UNITED STATES PATENT AND TRADEMARK OFFICE

APPLICATION NO.	FILING DATE	FIRST NAMED INVENTOR	ATTORNEY DOCKET NO.	CONFIRMATION NO.
10/787,426	02/26/2004	Xiaoyu Li	DP-310234 (60,408-414)	4773
22851	7590	11/01/2006	EXAMINER	
DELPHI TECHNOLOGIES, INC.			ILAN, RUTH	
M/C 480-410-202			ART UNIT	
PO BOX 5052			PAPER NUMBER	
TROY, MI 48007			3616

Office Action Summary	Application No.	Applicant(s)	
	10/787,426	LI ET AL.	
	Examiner	Art Unit	
	Ruth Ilan	3616

DETAILED ACTION

FIG. 6

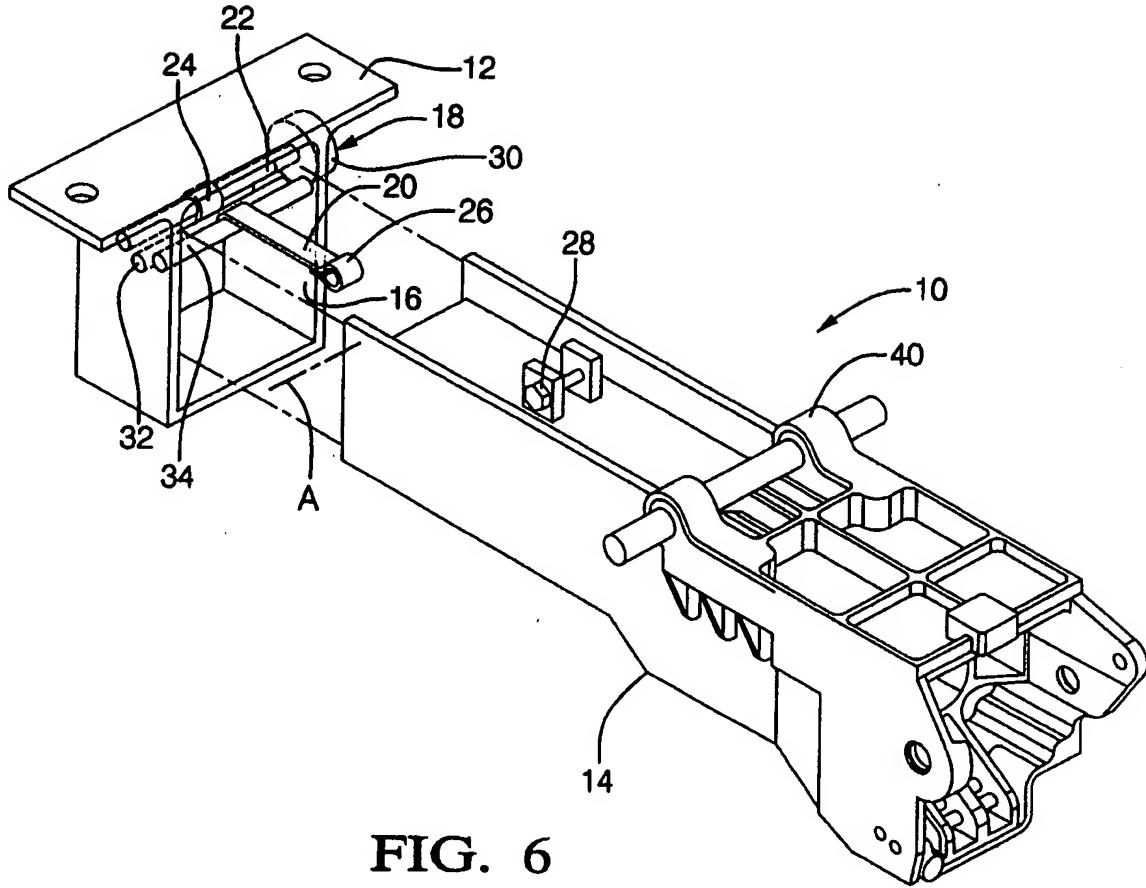
1. The drawings were received on 8/15/06. These drawings are not accepted.
2. New Figure 6 is not accepted for two reasons: First, it introduces new matter. 35 U.S.C. 132(a) states that no amendment shall introduce new matter into the disclosure of the invention. The added material which is not supported by the original disclosure is as follows: New Figure 6 includes a very different support than that shown in Figure 4, and as such it is not clear how the elements correspond. In addition to the new matter issues, it is not understood how the configuration shown in Figure 6 works. As connected in new Figure 6, the strap would "bunch up" rather than get pulled out from the brake.

3. The drawings are objected to under 37 CFR 1.83(a). The drawings must show every feature of the invention specified in the claims. Therefore, the elongated element with the second end fixed to the steering column must be shown or the feature(s) canceled from the claim(s). No new matter should be entered.

Corrected drawing sheets in compliance with 37 CFR 1.121(d) are required in reply to the Office action to avoid abandonment of the application. Any amended replacement drawing sheet should include all of the figures appearing on the immediate prior version of the sheet, even if only one figure is being amended. The figure or figure number of an amended drawing should not be labeled as "amended." If a drawing figure is to be canceled, the appropriate figure must be removed from the replacement sheet, and where necessary, the remaining figures must be renumbered and appropriate
